MIL-PRF-19500/276D
AMENDMENT 1
8 December 2002

PERFORMANCE SPECIFICATION

SEMICONDUCTOR DEVICE, THYRISTORS (CONTROLLED RECTIFIERS), SILICON TYPES 2N2323, 2N2324, 2N2326, 2N2328, 2N2329 AND S VERSIONS 2N2323A, 2N2324A, 2N2326A, 2N2328A, 2N2329A AND S VERSIONS JAN, JANTX, JANTXV, AND JANS

FIGURE 3. Blocking-voltage test. ”

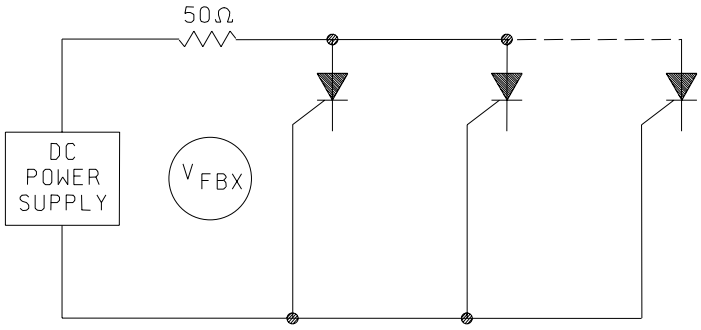
FIGURE 3, delete and substitute;
“

Procedure: Adjust the power supply to the specified value for the device under test.

NOTE:
1. Rate of rise of voltage must be limited to values specified in table I.
